PART 573 Defect and Noncompliance Report

On July 1, 2014, LiquidSpring LLC decided that a defect which relates to motor vehicle safety exists in items of motor vehicle equipment listed below, and is furnishing notification to the National Highway Traffic Safety Administration in accordance with 49 CFR Part 573 Defect and Noncompliance Reports.

Equipment Brand or Trademark: CLASS (Compressible Liquid Adaptive Suspension System)

The item of equipment subject to the recall is a fluid volume mount bracket of the suspension system. The following suspension models and manufacture dates are the affected population.

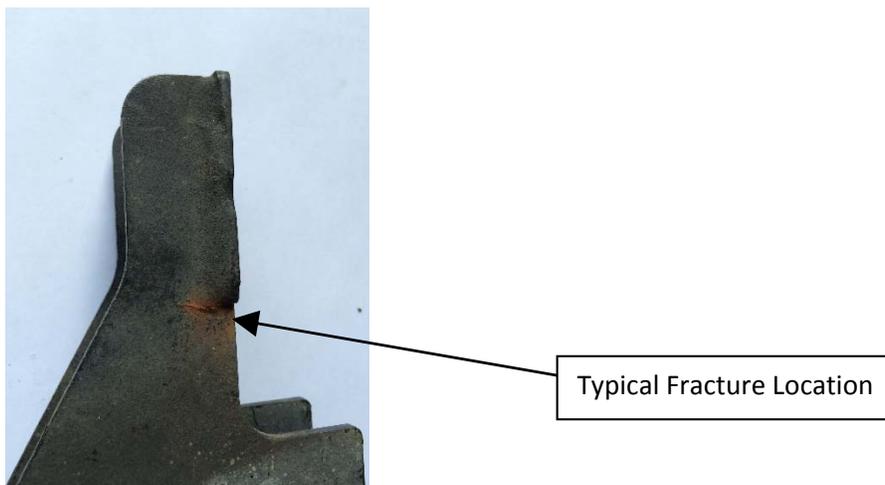
The volume mount bracket affixes a fluid volume to the chassis frame. There are 2 fluid volume mount brackets per fluid volume and 2 fluid volumes per suspension system. Therefore, each suspension system has 4 fluid volume mount brackets affected by the recall. See illustration below for typical fluid volume mount brackets on one side of the chassis.

Description of the Defect: The fluid volume mount bracket can develop a complete fracture such that the bracket separates from the chassis frame and is unable to provide support for the fluid volume at the bracket location.

Cause of the Defect: The cause of the defect is material fatigue in a portion of the fluid volume mount bracket due to application load conditions. More severe duty service conditions increase the likelihood of fracture initiation and propagation.

Consequence(s) of the Defect: The consequence of the defect can be a complete fracture in the fluid volume mount bracket such that the fluid volume becomes unsupported by the bracket at the fractured bracket location and the hose connection at that end of volume becomes the fluid volume supports means. The hose connection(s) will likely support the volume for at least a short period of time until detection, however, they are not intended as the primary support means for the fluid volume. If undetected for a long period of time or ignored after detection, the hose connection(s) could fail resulting in the fluid volume contacting the ground.

The production remedy for the fluid volume mount bracket defect is implementation of a re-designed bracket that will not experience a fracture due to severe duty load conditions. The re-designed fluid volume mount bracket was implemented in production on all affected models manufactured on or after May 14, 2014. The re-designed bracket is readily distinguished from the original bracket.

The production re-designed fluid volume mount bracket is backward compatible with and a direct replacement for the original bracket. The company has covered the replacement expenses of the original fluid volume mount bracket in both the 1st and 2nd instances as well as the additional field review instance under warranty. Only the additional field review instance had the fluid volume mount brackets replaced with the re-designed version, therefore, the 1st and 2nd instances will require replacement of the fluid volume mount brackets.
